Verification Report

017

Riverside Academy

AREA SURVEYED: East Block Above Basal Layer Probes 6,7 and 8.

East Block Above Basal Layer Probes 6,7 and 8.

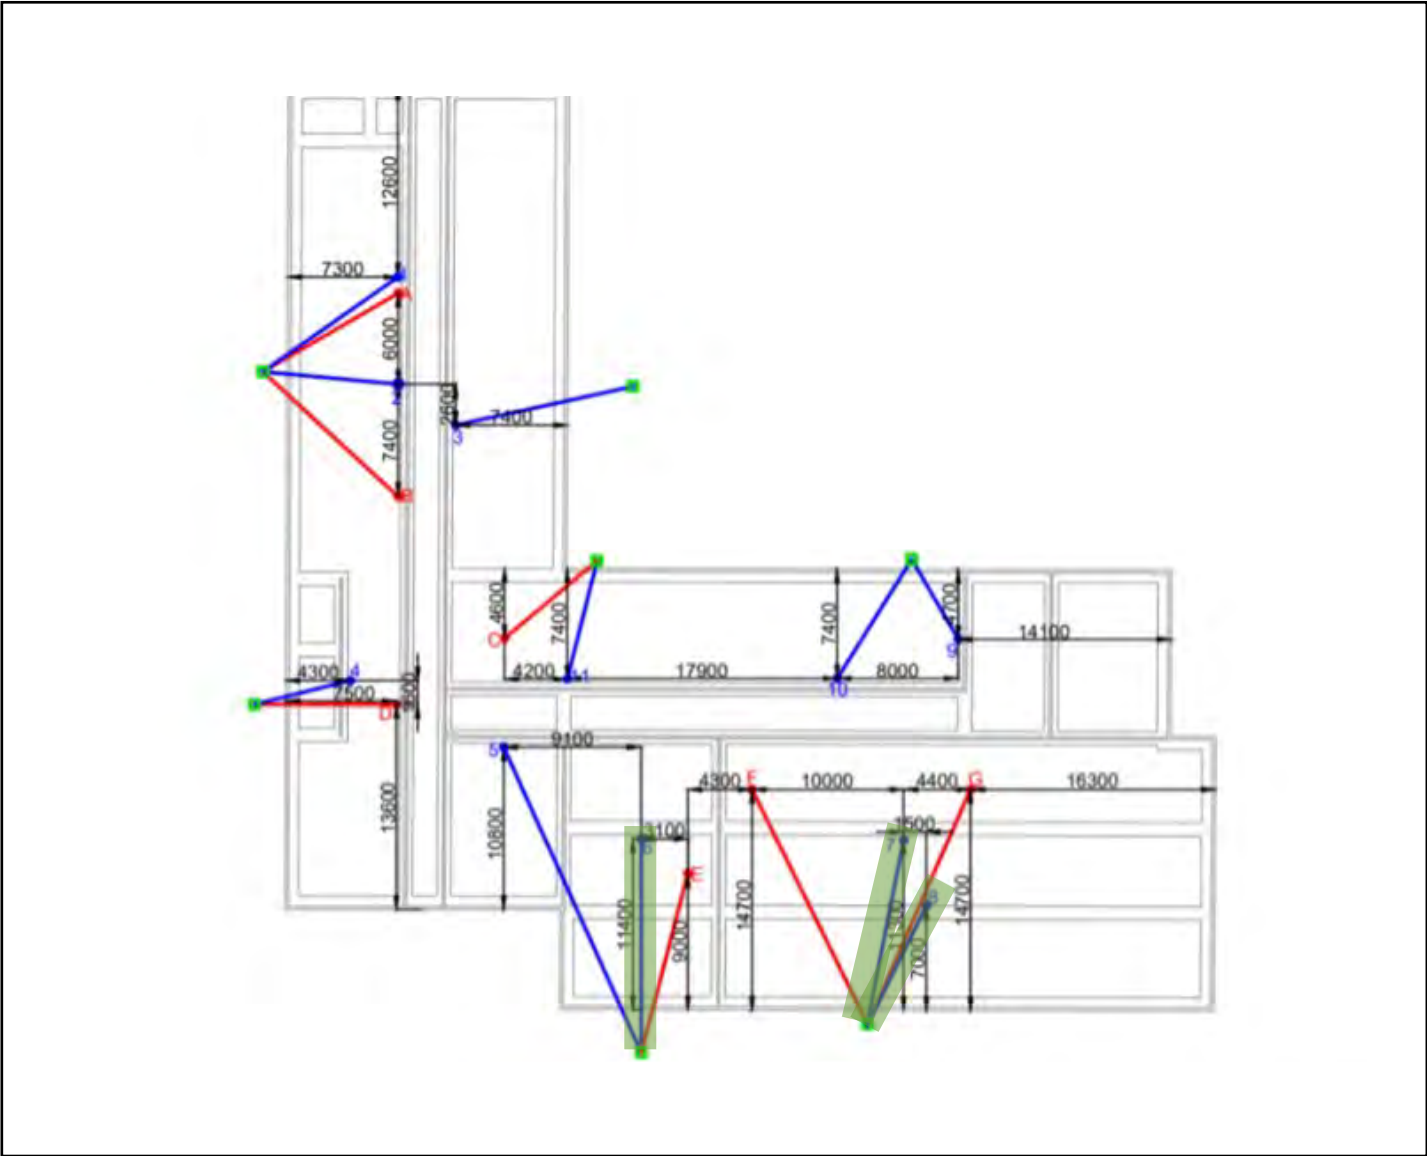
The above photograph displays a layout plan of East Block.

The above basal layer probes highlighted green above were verified during this visit.

LOCATION/GRID LINE: East Block Above Basal Layer Probes 6,7 and 8.

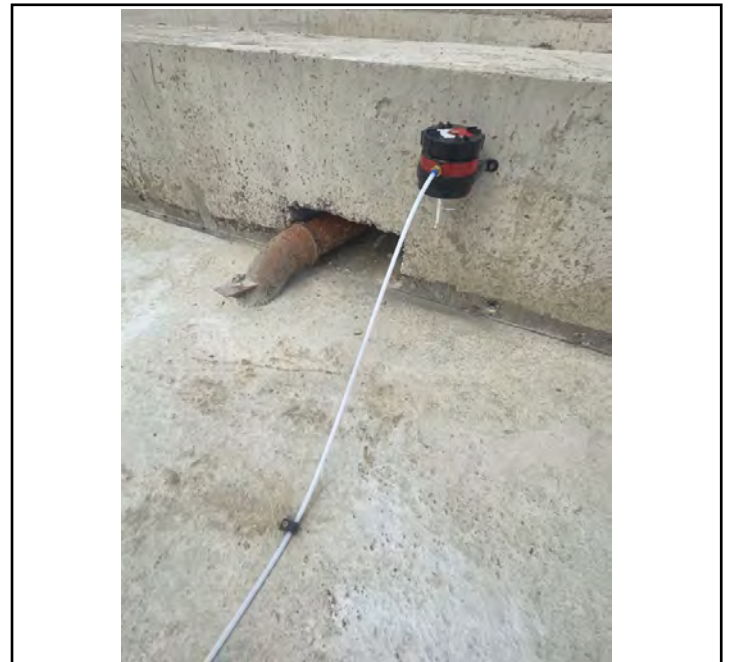
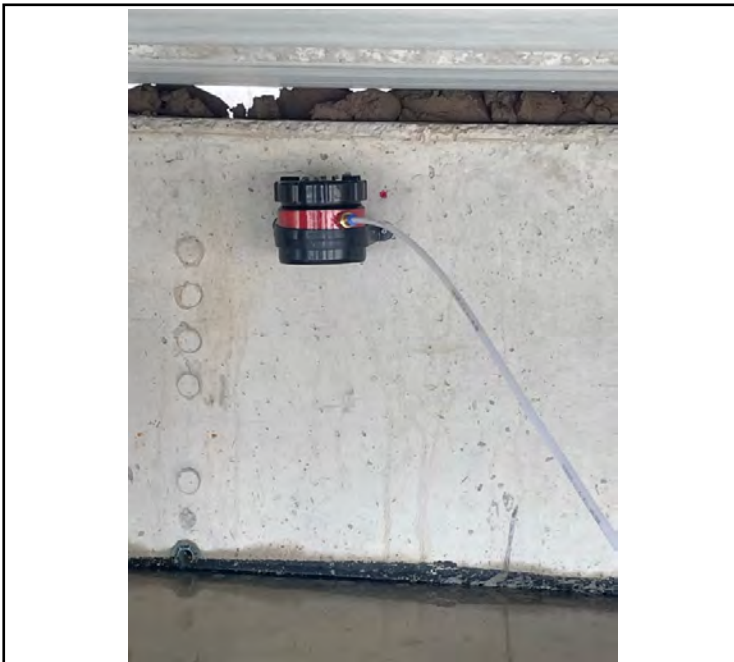
The remaining above nasal layer probes within the east block have now been successfully installed by the specialists Prestige Air. All monitoring probes have been installed as per Geoshields mark up. However, the probe pipe routes have differed due to obstructions.

The above photographs display the ground gas monitoring probes securely fixed upon the concrete walls.

VERIFICATION ITEM THREE

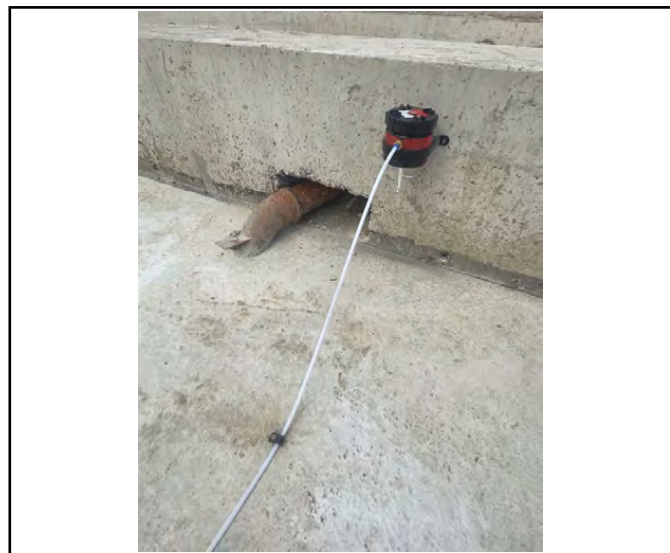
The probe pipe has been returned immediately through hard PVC pipe work

vertically up against the concrete perimeter walls in which the ground gas monitoring

works will be carried out on future visits.

Evidence of this shown above.
